Meadowood Special Recreation Management Area
Bureau of Land Management
10406 Gunston Road, Lorton, VA 22079
Parcel Identification. no.: 11430 01 0040

Barn/Arena Assessment

December 2010

Aerial view of Meadowood Barn/Arena

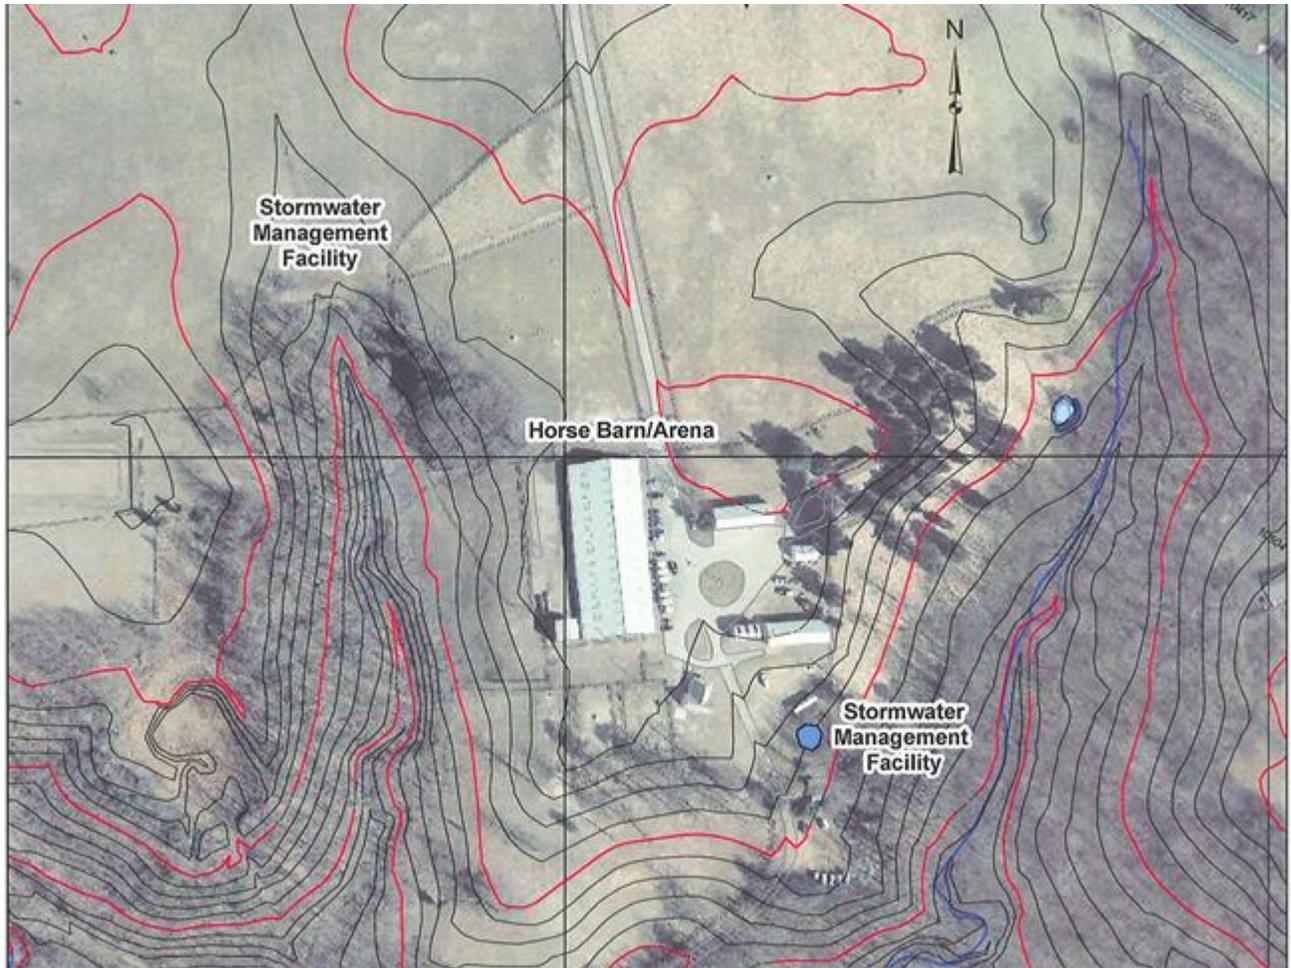
The property is located in the Kane Creek Watershed of Fairfax County. The site immediately surrounding the barn/arena drains east and west into two on-site streams that run south and converge before outfalling into Belmont Bay. The existing site appears to have inadequate Stormwater Management (SWM) measures. The only structural SWM measures observed on-site were two small dry ponds; one south-east of the arena and another to the north-west.

To the east of the arena, stormwater runoff from the roof of the barn/arena is collected in a series of roof drains that outfall at ground level. Runoff from the east half of the roof discharges from the roof drains into a small swale running south, parallel to the barn/arena, sheet flows across the parking lot into two asphalt channels, and is then piped into a small dry pond south-east of the building. A PVC pipe is used as an outlet structure, which outfalls into a small stream, where signs of erosion are visible at the outfall point. BLM staff indicated that during large storm events, water appears to be infiltrating the foundation along the south eastern side of the barn/arena. They believe this infiltration is caused by the runoff from the roof drains.

At the north end of the arena, the runoff from the roof drains sheet flow around the building to the west. BLM staff noted that the stalls at the north end of the site often get flooded during large storm events. See image below:

The velocity of the stormwater runoff from the arena roof, parking lot, and horse pastures should be reduced to allow for infiltration. BLM staff has started taking measures to address this issue by restricting horse access from various hillsides, and planting them with native grasses and trees.

Low impact development (LID) and Best Management Practices (BMPs) should continue to be researched and implemented in order to reduce pollution from runoff, flooding of the arena, and erosion of the adjacent streams. Examples of LID and BMPs include, but are not limited to: rain gardens, porous pavement, and cisterns. Cisterns can be used to collect stormwater runoff from the roof drains, which may then be reused for other purposes. Installing rain gardens and replacing some of the existing asphalt with porous pavement can

Daylight can be seen through rotten areas of truss chord members

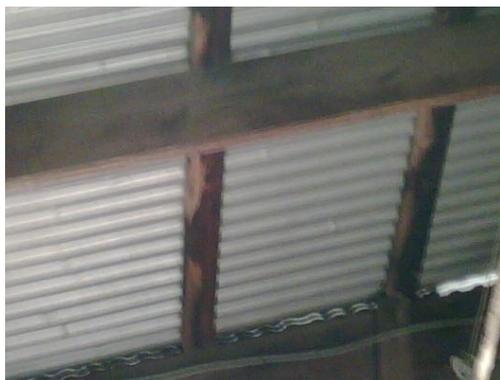
- The wood in the trusses at the north end of the barn are experiencing severe wood rot due to water infiltration. It is not prominent throughout, but is serious in multiple locations and should be addressed. See image below:

- **Arena Trusses-** An analysis must be conducted to ensure the trusses have a capacity to resist the current loads (snow, dust control water pipes, various wood supports, etc.) and future loads, such as a sprinkler system. The bracing should also be checked to ensure truss stability is maintained. **The north end trusses experiencing wood rot must be replaced or repaired immediately.**
